Re: Kilarc-Cow Creek {FERC P-606} CEQA

SOUTH COW CREEK {FERC P-606} DIVERSION DAM AREA “PG & E CLEAR CUT OPERATION in MARCH 2011”

Figure 1
South Cow Creek Diversion Area
 * Green Outline : Riparian Vegetation
 * Cross-hatched Green: "Clear Cut" area
 * Blue Outline: Water's edge -either Creek or Cana

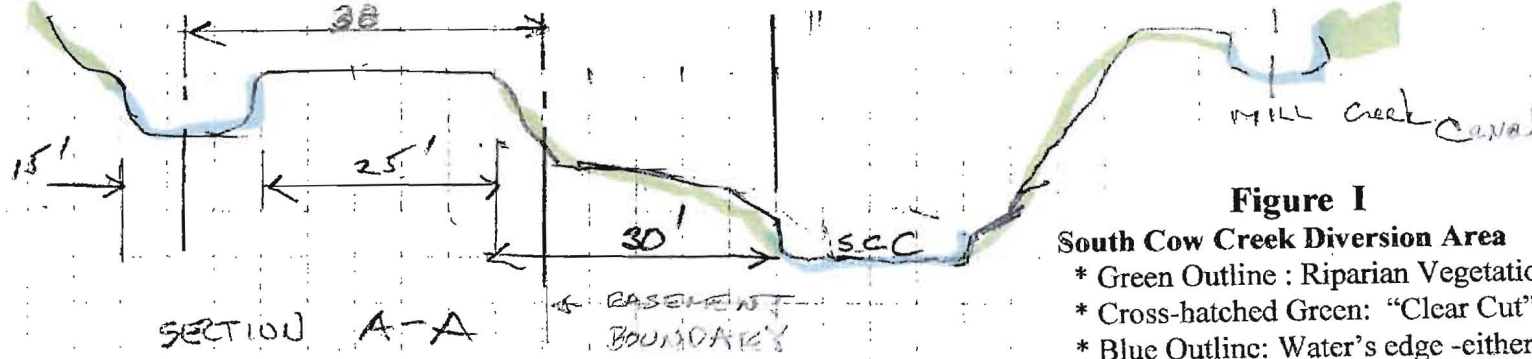
2. All mature riparian vegetation (mostly Alder and Willow) was cleared to the ground between the main canal berm all the to the very edge of South Cow Creek (a distance of about 30 ft.); and for an approximate length of 95 ft. (about 0.065 acres). The “clear cut area” is illustrated in a schematic diagram (Figure I, page 3) of this document {softcopy file is Page 3 001.jpg} The “Clear Cut” starts about 80 feet downstream of the Diversion Structure.

3. As shown in the Figure I schematic; on the main canal side before the 'clear-cut' area begins, there is now left standing downstream of the dam only about a 40 ft long X 40 feet wide stand of alders and willows. Unfortunately it seems it will be necessary to remove at least 50% of this remaining riparian vegetation during the dam removal process in order to remove the old "metal bypass pipe" that is embedded in this region. It would be totally inappropriate to leave such a metal structure in direct proximity of the Creek. Therefore if the dam is actually removed in the near future (< 3years), there effectively will be zero mature vegetation along the Creek bank on the main canal side for a distance of about 175 ft downstream of the dam location.

Figure II

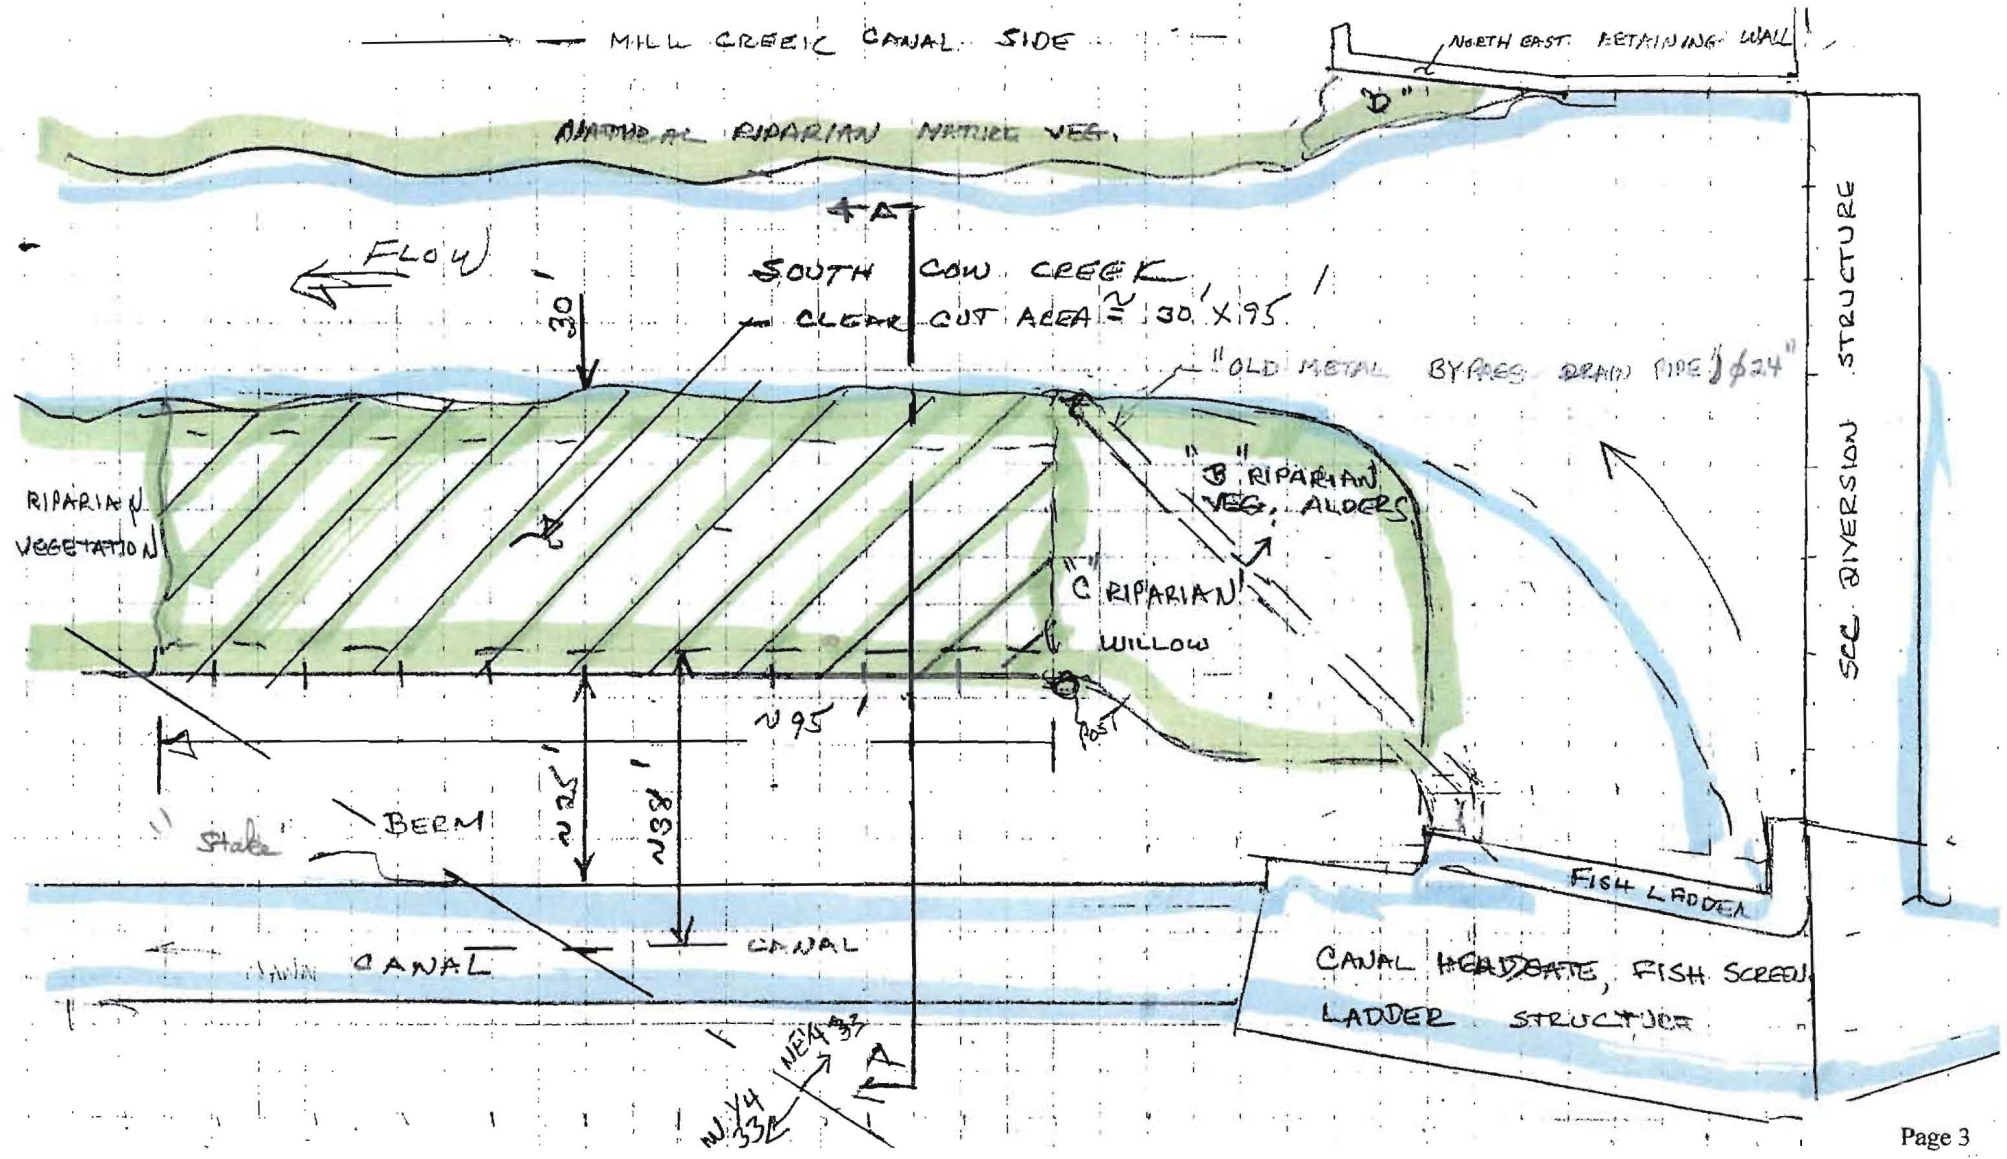
b. The “pre-cut” nature of the riparian vegetation lying along South Cow Creek is best understood from a “Google Earth” August 2010 aerial view of this area shown as Figure II on page 4 {Softcopy file is Page 4 001.jpg}. The 1907 deeded easement requirements of 75 feet for the Project bounds in the NE¼ of Section 33 are projected onto this Figure together with the generally accepted definition* of the N¼ point of Section 33. *Generally accepted means per PGE K-2 documents, PG&E LSA documents, USGA maps, projections from century old landowner fences, etc.

Figure III-B { South Cow Creek below dam just to left of Figure IV-A - July 2009}
+ Fish ladder just to left of this picture
+ *pointer represents corresponding areas between photos A & B

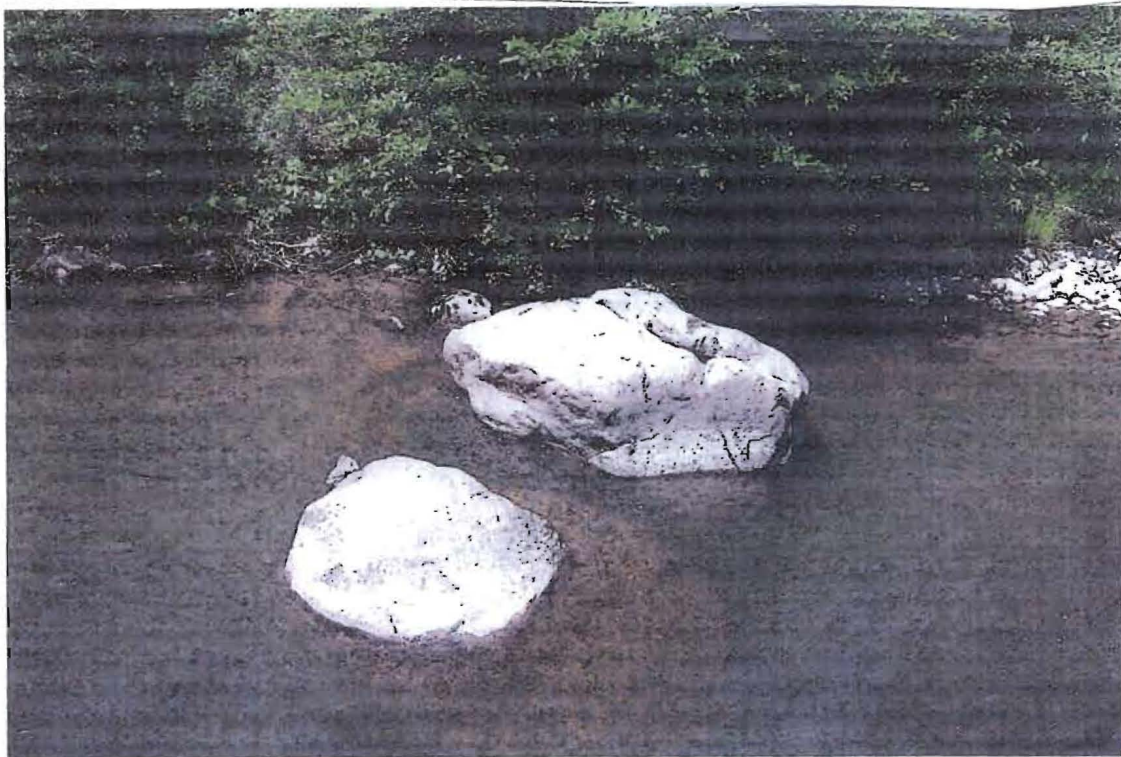
c. Figures III A & B { Page 5 001.jpg file} shows a 2009 lands eye view of South Cow Creek looking immediately downstream from points on the dam surface. Figure IV {Softcopy file Page6 001.jpg } shows the old bypass pipe exit in a 2009 picture at the Creek edge. This point is less than a yard upstream of where the 2011 March “clear-cut” was initiated.
